1985 - 1991 Corvette: Service Bulletin: Coated Wheel Weights For Aluminum Wheels

Subject: COATED WHEEL WEIGHTS FOR ALUMINUM WHEELS
Model and Year: 1985-91 MODELS WITH CAST ALUMINUM WHEELS

Bulletin Number: 91-35-3E - (06/29/1990)

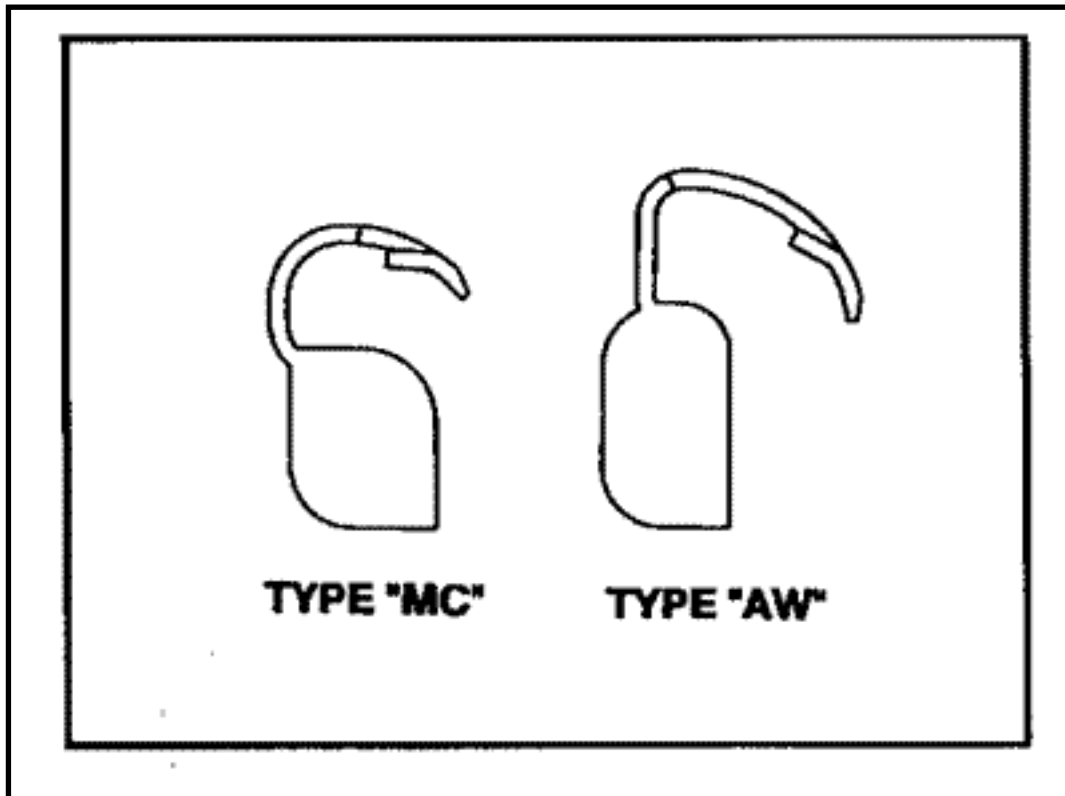
Vehicles with cast aluminum wheels use a coated clip on wheel weight. The coating has recently changed from nylon to polyester, giving a more natural appearance that more closely matches the wheel. Coated balance weights are used on both the inboard and outboard rim flanges. They will not discolor, corrode or damage the appearance of the wheel as may have been the case in the past with uncoated clip on weights. These coated weights will fit most GM cast aluminum wheels.

There are two types of coated wheel weights available to fit the GM vehicles (see illustration). Both types of weights are available from GMSPO in 1/4 ounce increments. See usage chart below to determine which type weight is correct for the vehicle.

When installing the coated weights, care must be taken so that the coating does not crack. It is recommended that a Teflon tipped hammer be used, such as 85403 Nicholson Industrial Hammer, their part number CAS 3340551, available through the Charles Strelinger Company, Warren, MI (313-268-4100), or equivalent.
